Customer	: CU-DAR001 Dart Helicopters Services	Drawing Name	: HELI UTILITY BASKET LH/RH 350/355
Job Number	: 45368		
Estimate Number	: 10208		
P.O. Number	:	Part Number	: D350607043
This Issue	: 29/01/2009	S.O. No.	:
Prsht Rev.	: NC	Drawing Number	: D350-607 REV F P7-9
First Issue	: / /	Project Number	: N/A
Previous Run	: 45359	Drawing Revision	: F
	Type : LARGE FAB ASSY	Material	:
Written By	:	Due Date	: 05/02/2009
Checked & Approved By	: <u>JLD 09.02.09</u>	Qty:	1 Um: Each
Comment	: Est Rev:E as Per DSI9318 06-01-24 JLM Est Rev:F ECN1068 07-12-21 DD verified by:

DESIGN <i>CP</i>	DRAWN BY <i>CP</i>	DART AEROSPACE LTD HAWKESBURY, ONTARIO, CANADA	
CHECKED <i>[Signature]</i>	APPROVED <i>[Signature]</i>	DRAWING NO. DSI 9318	REV. A SHEET 1 OF 1
DATE 06.01.06		TITLE WASHER ADDITION	SCALE NTS
A	06.01.06	NEW ISSUE

DART SERVICE INSTRUCTION

TO AMEND INSTALLATION INSTRUCTIONS D350-607 REV. F

Figure 5- Basket Replacement Parts
(D350-607-043 Heli-Utility-Basket™)

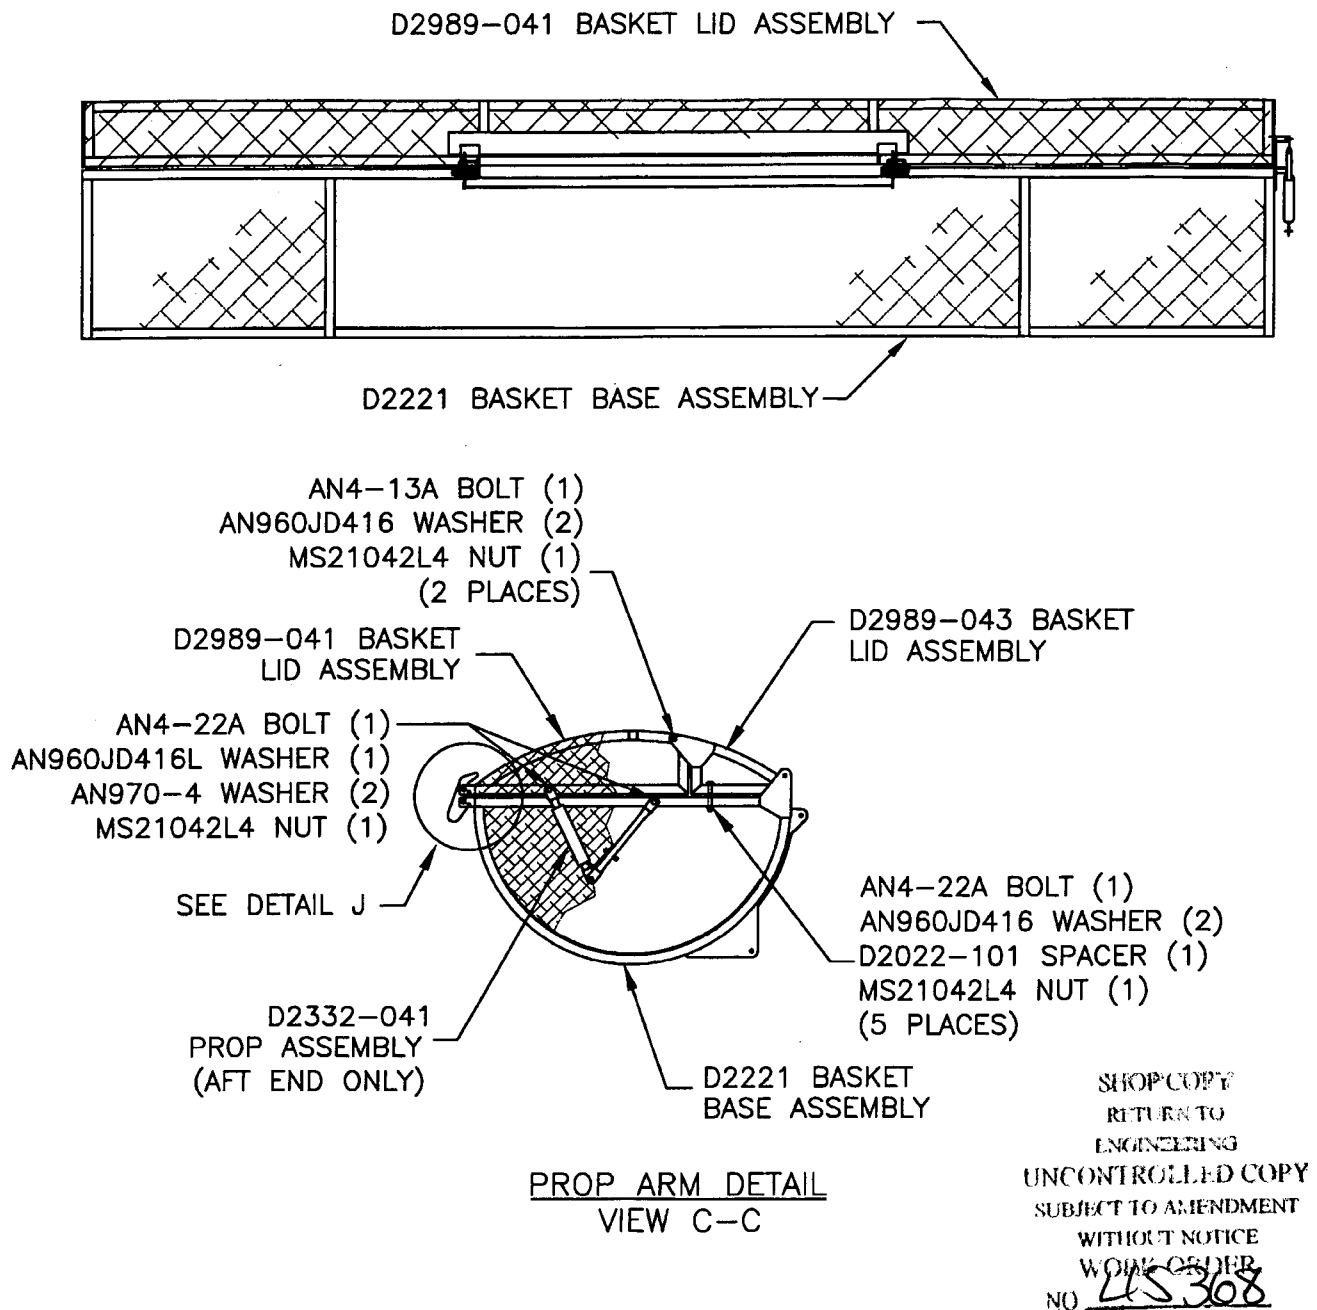
The corrected bolt stackup from Figure 5 of installation instructions D350-607 Rev. F is given below:

AN4-13A BOLT (1)
AN960JD416 WASHER (1)
HINGE PLATE (REF)
NAS1515H4 WASHER (1)
BASKET FRAME (REF)
AN960JD416 WASHER (1)
MS21042L4 NUT (1)
(2 PLACES)

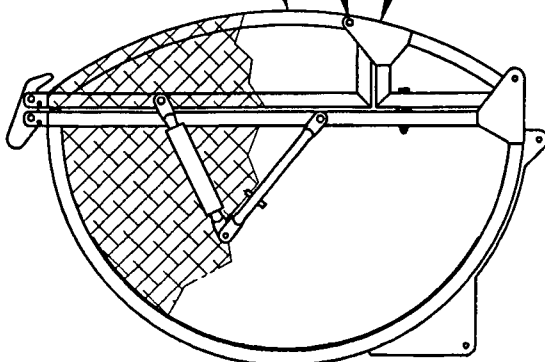
To reduce the possibility of damaging the finish, a **NAS1515H4** washer (2 places) has been added between the hinge plate and basket frame on the **D350-607-043/-047 Heli-Utility-Basket**.
